City of Temple City

Staff Report

FILE:	PL 19-2207
ADDRESS:	10660 Daines Drive
DESCRIPTION:	Vesting Tentative Parcel Map No. 82993 and site plan review for a lot-split subdivision with the construction of a new single-family residence on each of the new parcels. The property is in the R-1 Zone and is designated for low-density residential developments.
APPLICANT:	Richard Chu (Applicant's representative)
PROJECT PLANNER:	Hesty Liu, AICP, Associate Planner
ENVIRONMENTAL REVIEW:	This project is exempt from the California Environmental Quality Act (CEQA) pursuant to Section 15303 (New Construction or Conversion of Small Structures) and Section 15315 (Minor Land Divisions) of the California CEQA Guidelines.
RECOMMENDATION:	Adopt the attached Resolution finding that the project is exempt from CEQA and approving File 19-2207, subject to the recommended conditions of approval.

Figure 2: Project Plot Plan

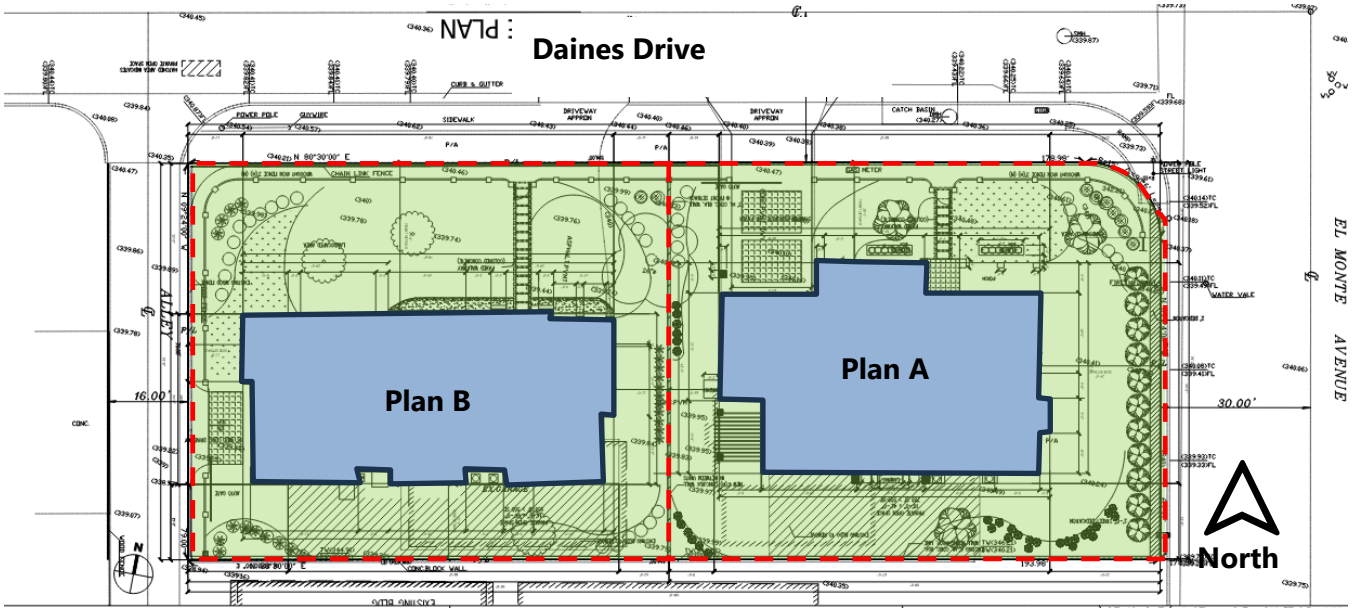
The applicant proposes to subdivide the property into two parcels through the midpoints of the side property lines. The new parcel on the east will be 98 feet wide, 79 feet deep, with a land area of approximately 7,694 square feet. The new parcel on the west will be 96 feet wide, 79 feet deep, with a land area of approximately 7,584 square feet. For each of the new parcels, the applicant proposes to build a new two-story single-family residence and an attached two-car garage. Plan A features a new residence on the easterly parcel which contains 3,200 square feet of floor area.

Plan B features a new residence on the westerly parcel which contains 3,155 square feet of floor area. Both residences will have four bedrooms and four-and-half bathrooms. Figure 1 on the previous page is the aerial photo showing the existing condition on the property. Figure 2, below, shows the proposed subdivision and the site design. For detailed building designs, please refer to Attachment 2 of this report.
